ANGEL'S LANDING

An Addition to Sedgwick County, Kansas

RE: SUB 2002-19 -- Final Plat of Angel's Landing Addition

At the regular meeting of the Subdivision Committee of the Metropolitan Area Planning Commission on Thursday, April 11, 2002, the above captioned plat was considered. The action of the Committee was to approve the one-step final plat, subject to the following:

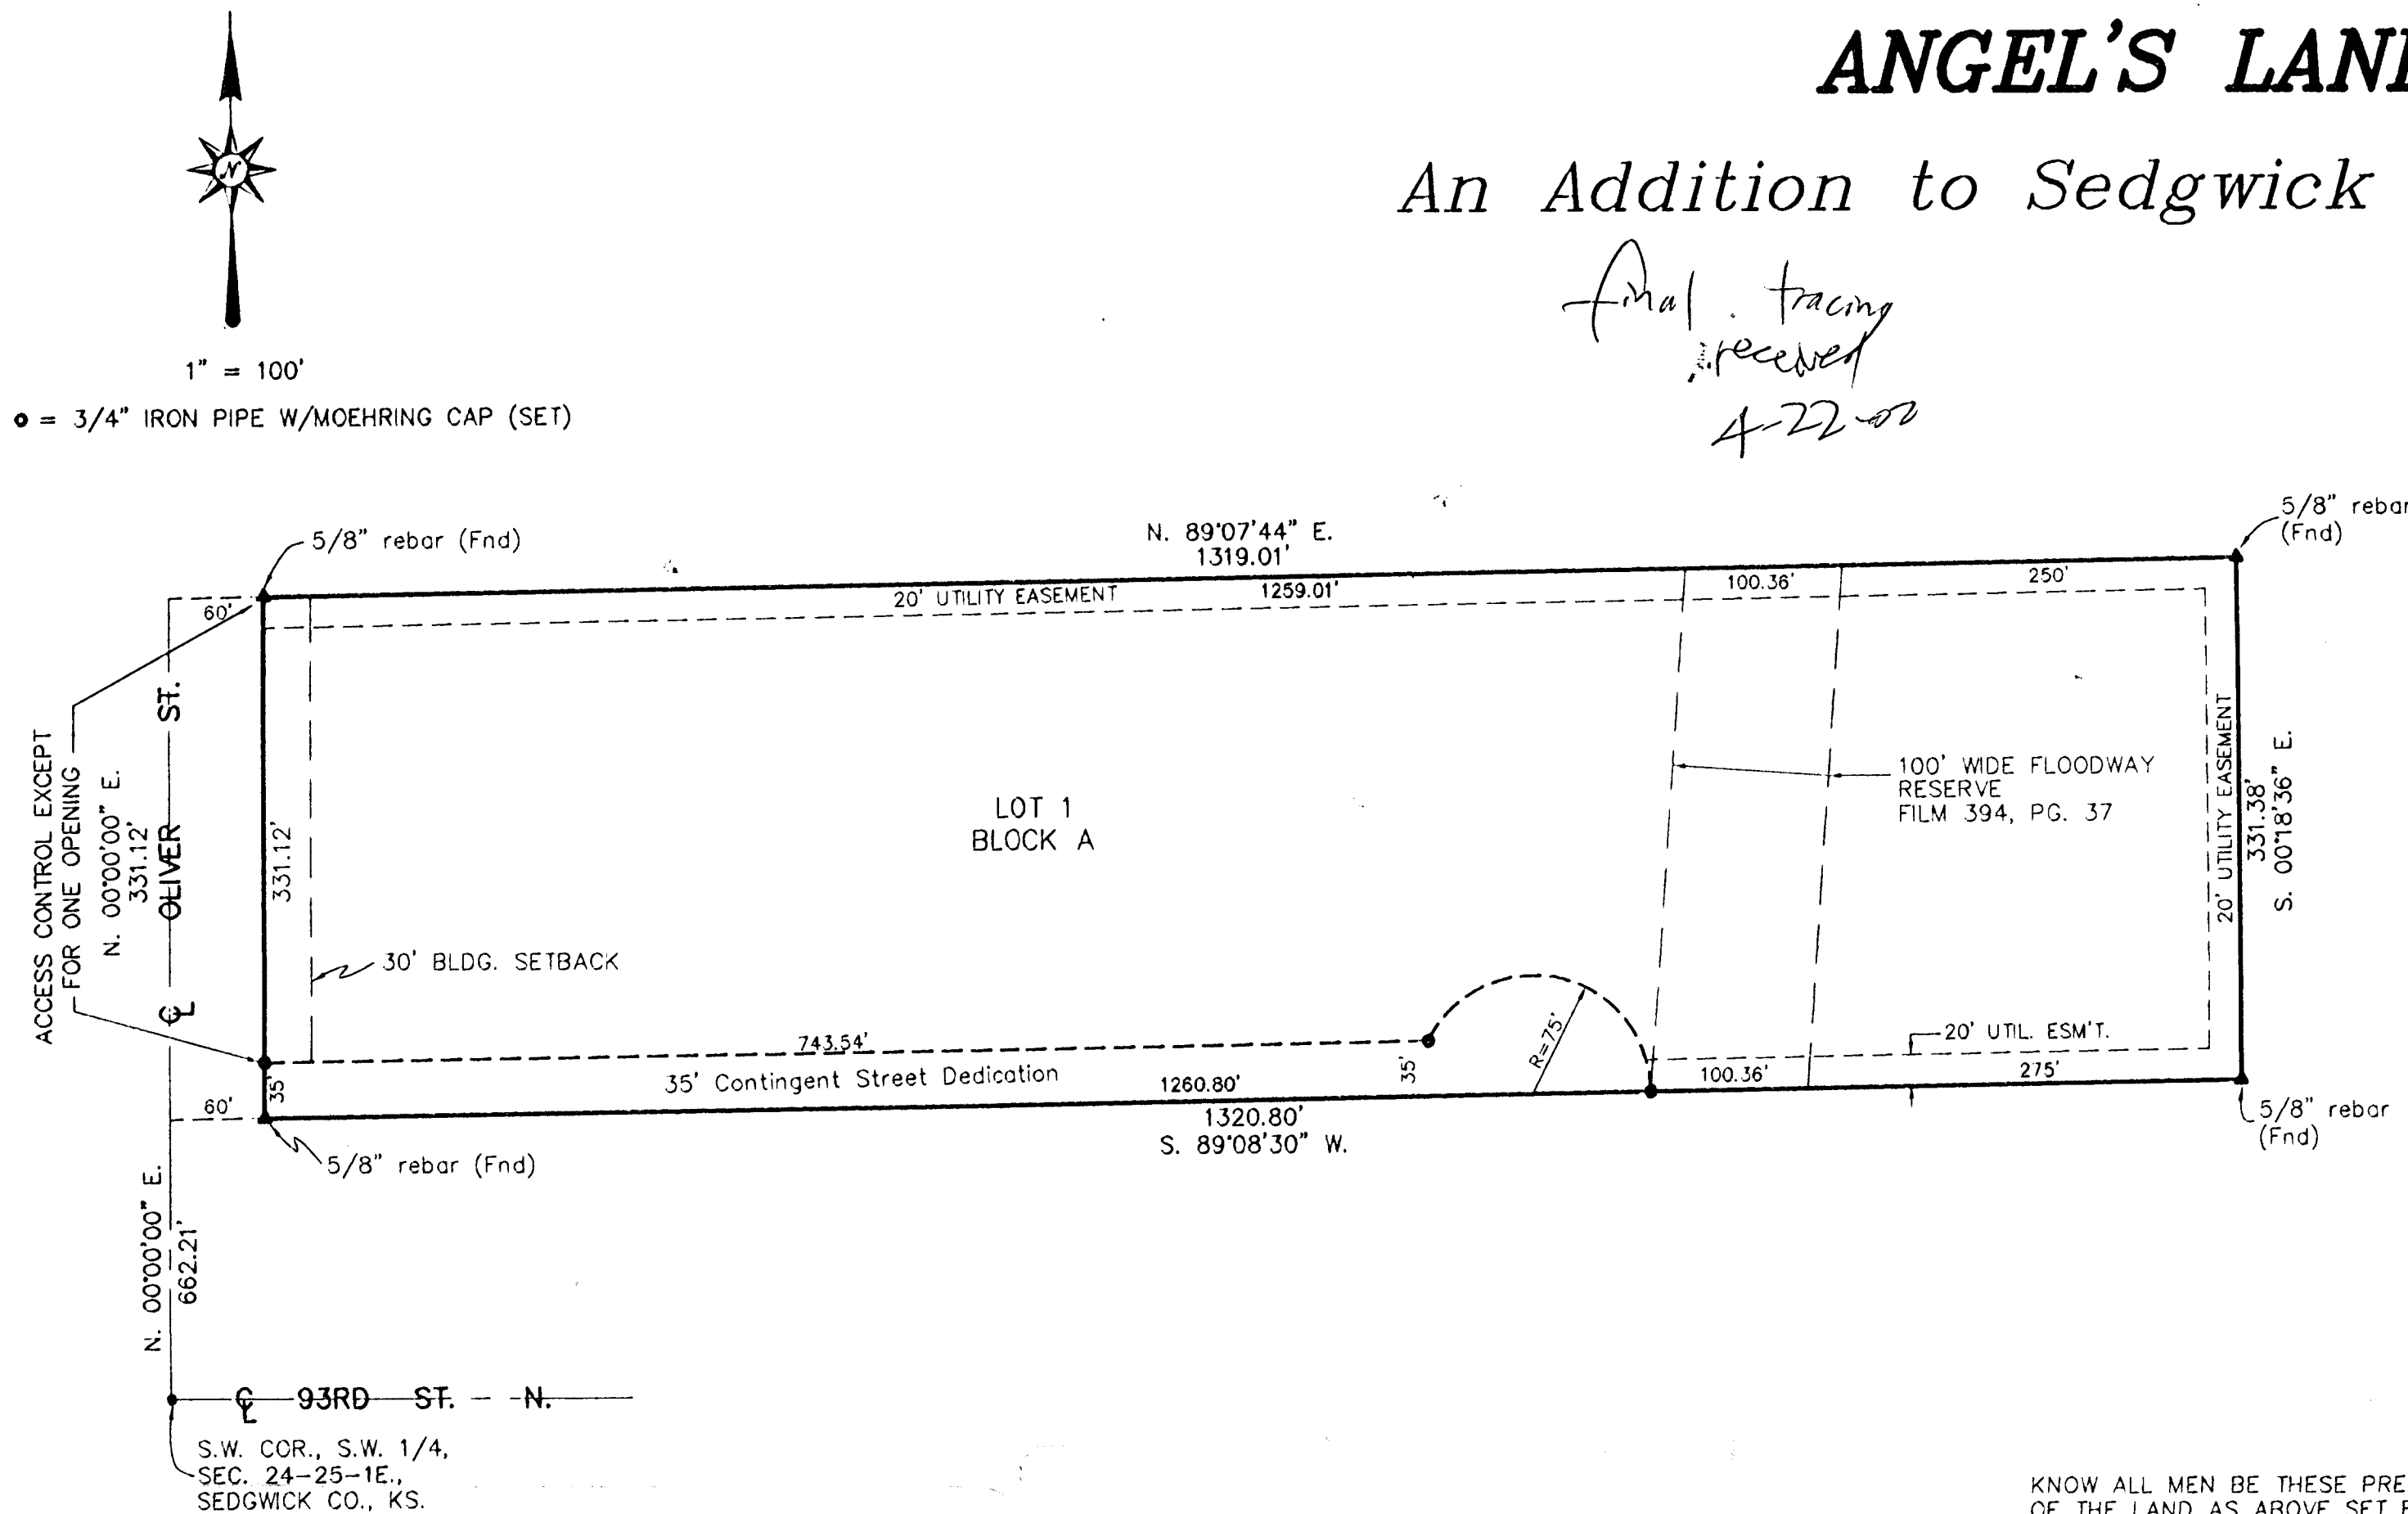
- E. The Applicant should provide a 35-ft contingent dedication of street right-of-way along the south property line, extending to the floodway reserve in order to provide potential street connection to adjoining properties. On the final plat, the contingent dedication of right-of-way needs to be referenced in the plat's text.

- G. The plat's text shall state that the access opening along Oliver would be required to be closed when the new street is constructed.
- H. The signature line for the County Commissioners Chairman needs to reference "Ben Sciortino".

- I. Approval of this plat will require a waiver of the lot depth to width ratio of the Subdivision Regulations. The Subdivision Regulations state that the maximum depth of all residential lots shall not exceed 2.5 times the width. The Subdivision Committee has approved the modification.

- K. The plat's text shall include language that a drainage plan has been developed for the plat and that all drainage easements, rights-of-way, or reserves shall remain at established grades or as modified with the approval of the applicable City or County Engineer, and unobstructed to allow for the conveyance of stormwater.

The contingent street dedication has been provided as requested.
- F. **County Engineering** has required complete access control except for the south 35 feet.
